Wairau Blue-Green Network Stage 1 — A F Thomas Park

Concept Feasibility Report — Appendices A to F

Revision 0 | 04 July 2025

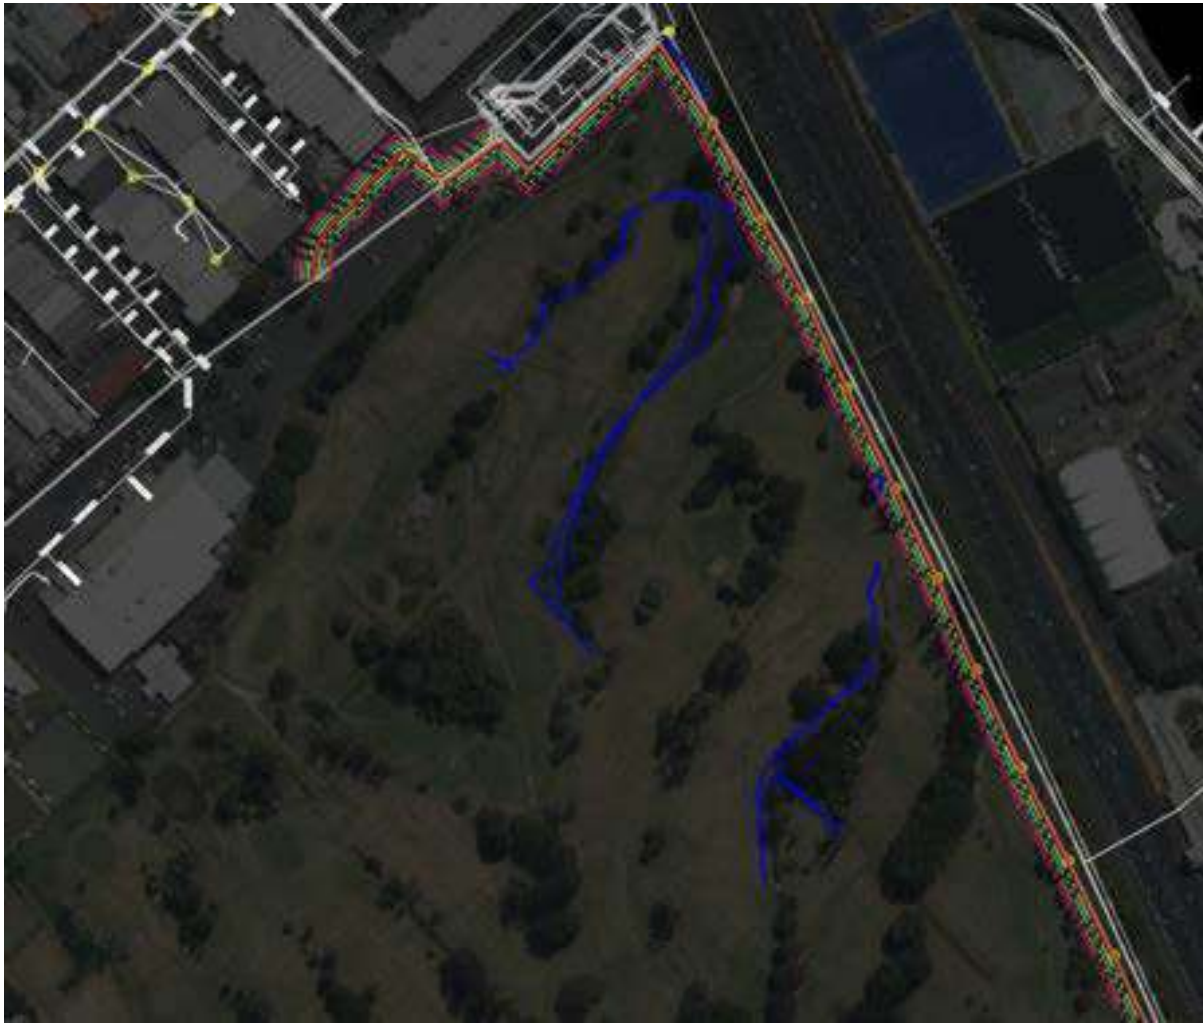
Finished contour plan SK08-2 shows the lowest area of the site being an area of 66,883m² at the 11.1mRL contour (shown below). This may be wetland to offset any stream loss from the works (yet to be determined), however is not required for flood mitigation or water treatment.

To assess what the estimated minimum wetland area may need to be, a best guess to allow for a minimum area of twice the existing ponding on site. We estimate the existing ponding area to be 2,422m² (the area shown below in the NE corner of the site defined by survey completed 30 May 2025), therefore twice this is 4,844m². By this logic the wetland shown is potentially 13 times larger than required. This is all dependant on the outcome of the ecological reporting.

For the purposes of the comparison, the TGC design should be comparable to the HWFR design. Therefore, apply whatever is most favourable (cost and benefit) to the feasibility assessment given the minimum and maximum wetted area available, including consideration of planting/mowing requirements. TGC will undertake to incorporate that in the next design iteration.

The area that isn't wetland can be grassed with planting at a density similar to the existing golf course situation.

Figure 2: Output of mounding between drains calculation (by WSP)

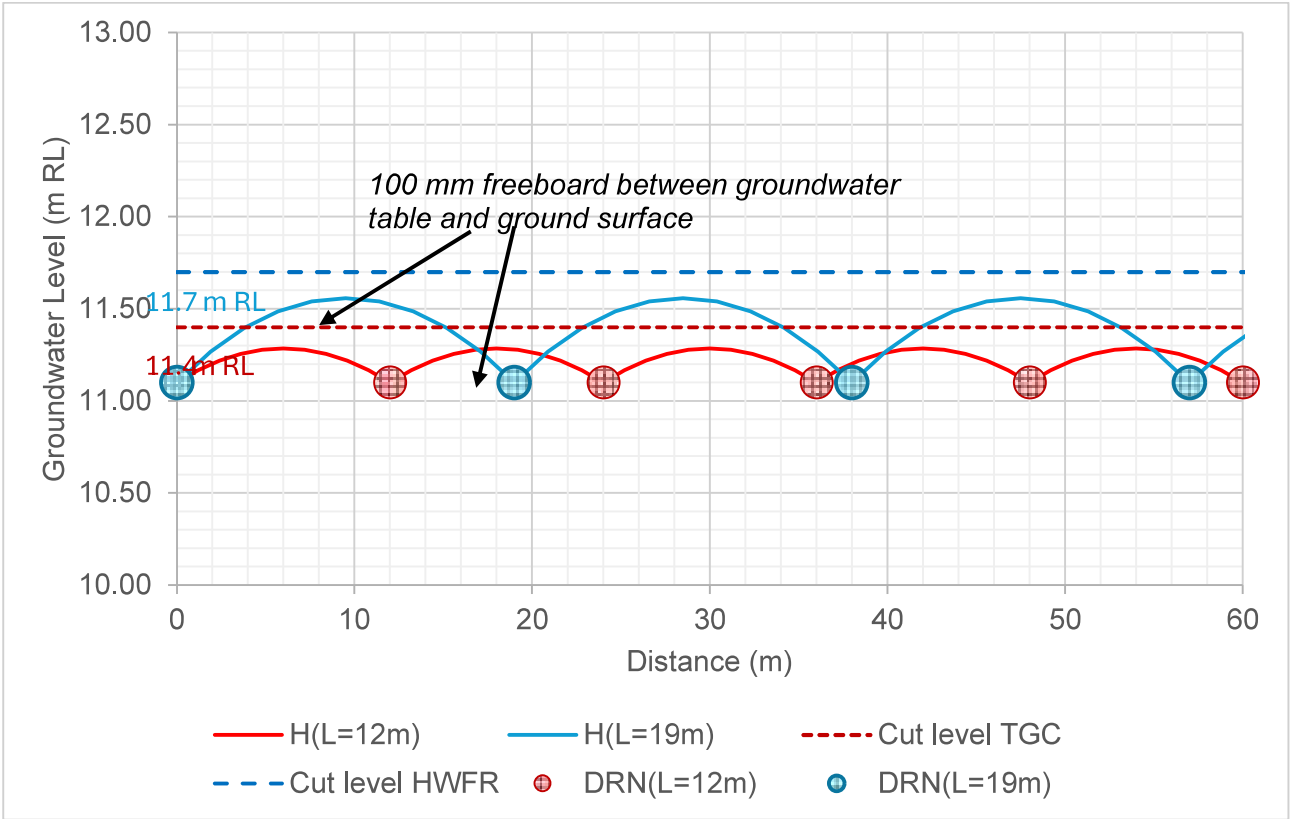
while the TGC would need drains every 12 m (Figure 2). It is important to note that this assumes the drains are equally effective between designs. However, the shallow fall of the TGC drains means these might be less effective, meaning that even more will be needed.

It should be noted this assessment is, by necessity, a simplification. At the upstream end of each proposal it is likely that increased density of drains will be needed as they will be shallower in these areas.
